Technical Service Information

THM 4L80-E

3RD GEAR STARTS & TIE UP IN MANUAL LOW

Figure 1

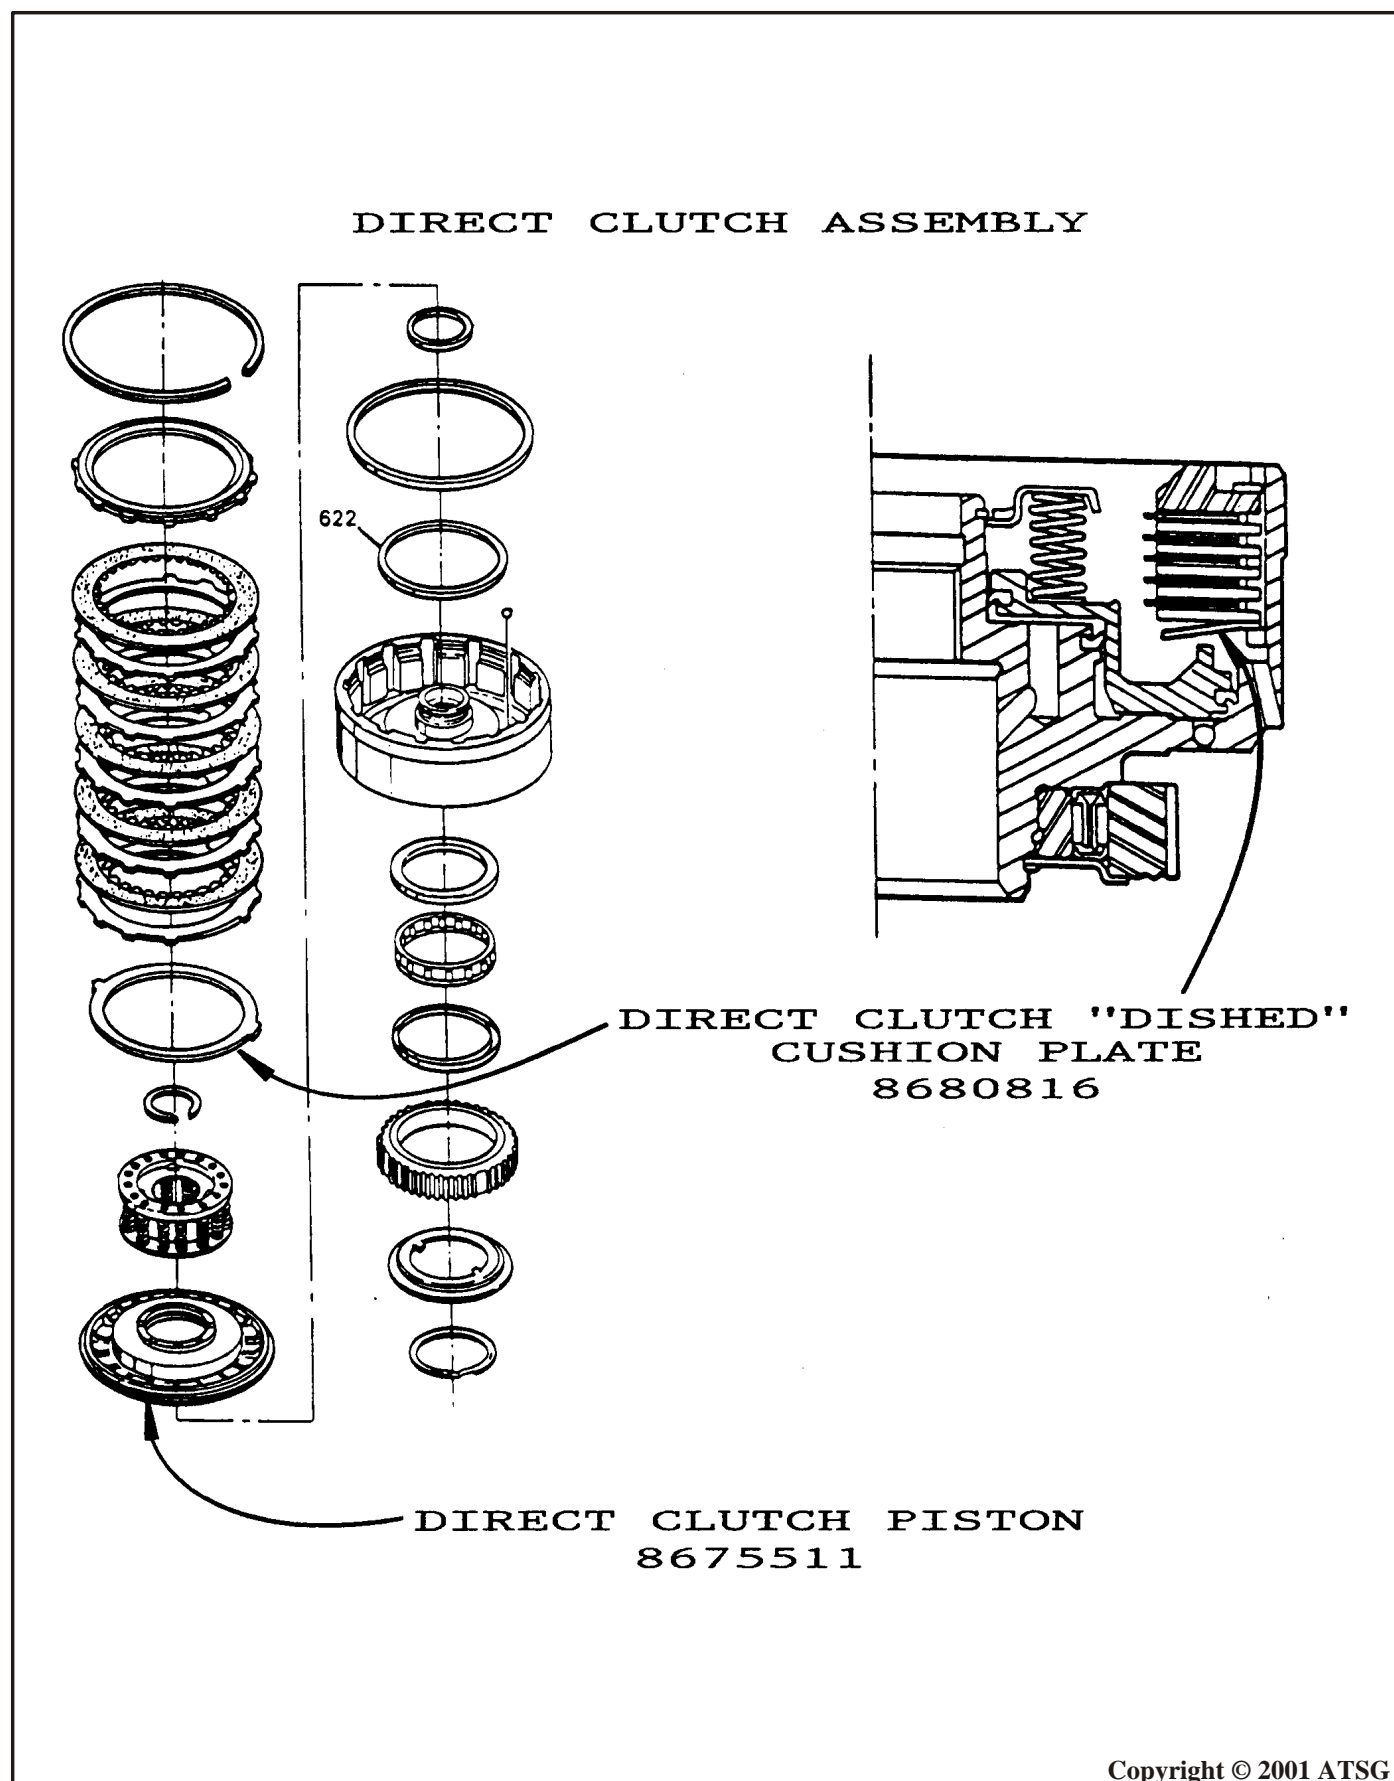
CORRECTION: **STEP 1:**
If the Direct Clutch Piston is broken replace it with a new one, OEM part number 8675511 (See Figure 1).

NOTE: The Direct Clutch "Dished" Cushion Plate goes into the direct drum, in the direction shown in Figure 1, so that the inside diameter is closest to the Direct Clutch Piston.

Figure 2

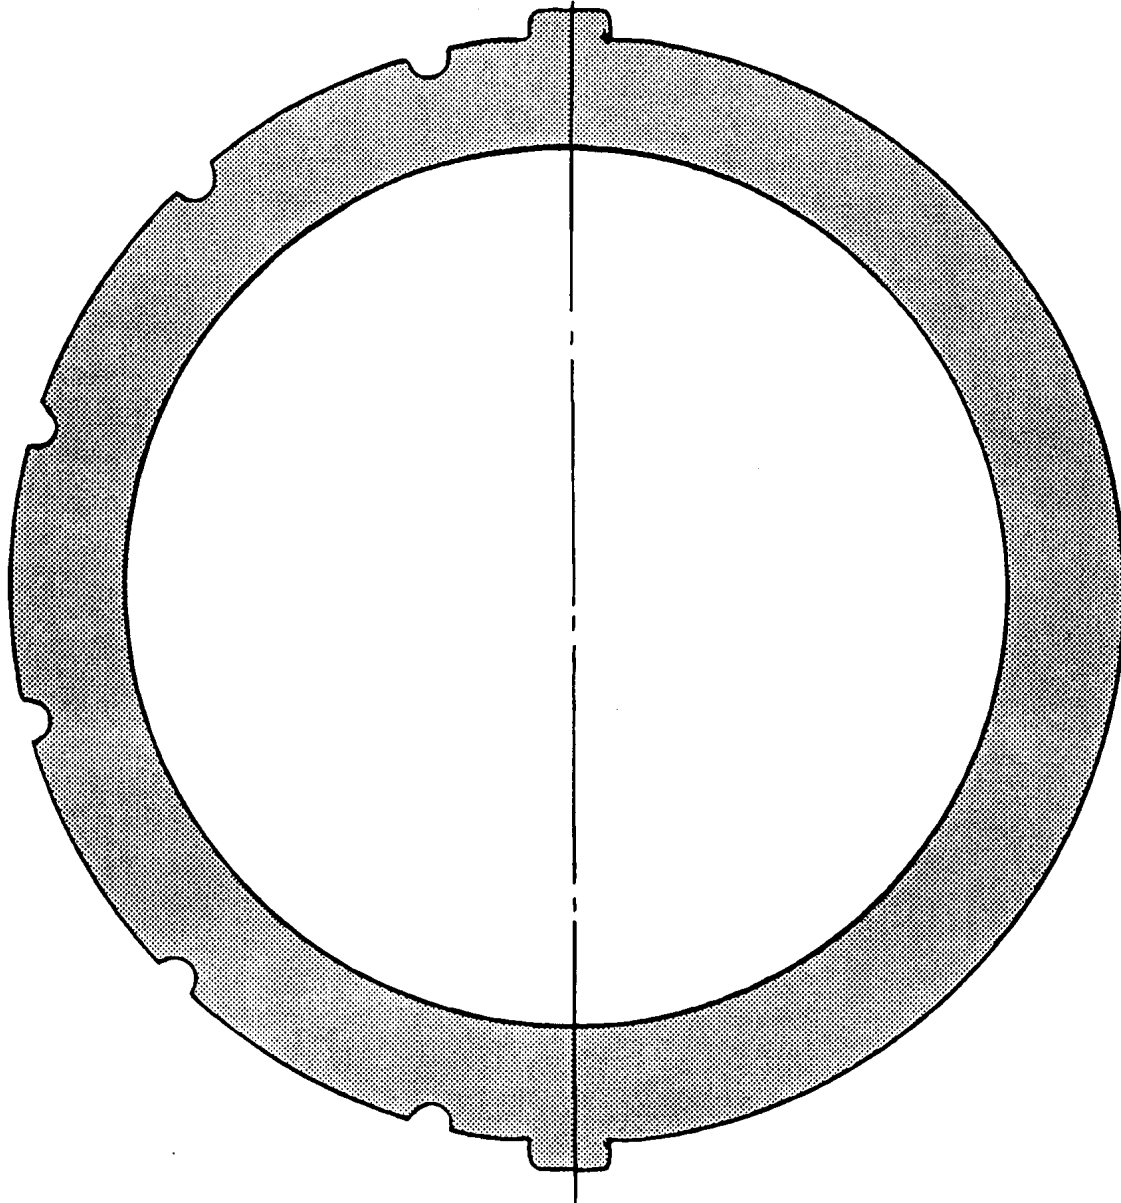
STEP 2:
If the Direct Clutch "Dished" Cushion Plate is broken replace it with a redesigned version, OEM part number 8680816. The new design "Dished" Cushion Plate does not have any notches cut into the outside diameter, as shown in Figure 2.

DIRECT CLUTCH "DISHED" CUSHION PLATE

1ST DESIGN
DO NOT USE!

2ND DESIGN
OEM PART NUMBER
8680816
